06-384r1 SAS-2 OPEN_REJECT RETRY during zoning changes

To: T10 Technical Committee
From: Rob Elliott, HP (elliott@hp.com)
Date: 1 September 2006
Subject: 06-384r1 SAS-2 OPEN_REJECT RETRY during zoning changes

Figure 1 — ZG change example

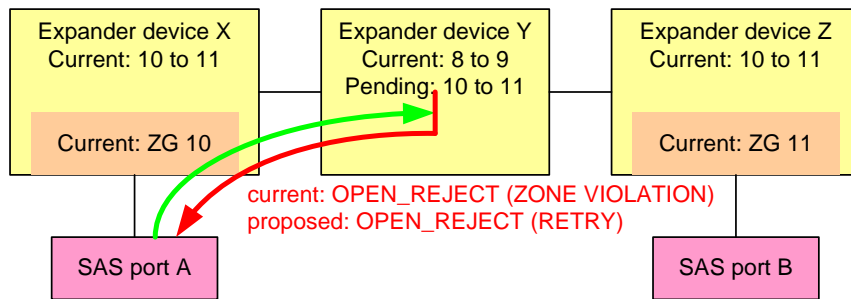
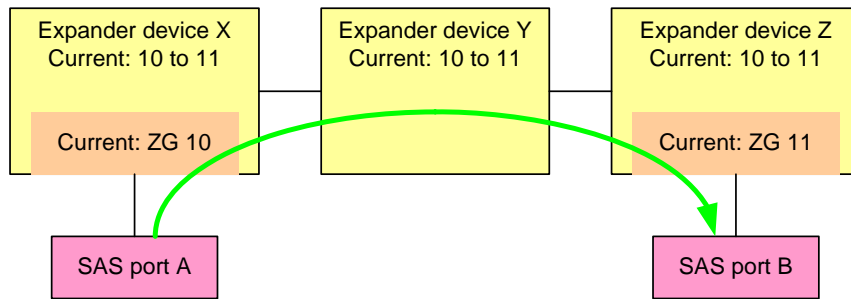
For example, assume a phy in zone group 8 has permission to access a phy in zone group 9. The zone manager is reassigning zone group numbers so those phys will change to zone groups 10 and 11. The expander devices that assigns the phys their zone groups is updated (both the zone phy information and the new zone permission table), then one of the phys transmits a connection request. The OPEN address frame is forwarded to another expander that is not yet activated, claiming a source zone group of 10. Since 10 did not have permission to access 11 in the old table, it gets rejected.

Note that the expander transmitting the OPEN_REJECT (ZONE VIOLATION) is one that has not yet been activated.

To avoid this, any locked expander device should return OPEN_REJECT (RETRY) rather than OPEN_REJECT (ZONE VIOLATION). A SAS port that receives OPEN_REJECT (RETRY) will try the connection request again (and not even run its I_T nexus loss timer) and not report failure to the application layer. This way, the I/Os will continue to operate during zoning changes.
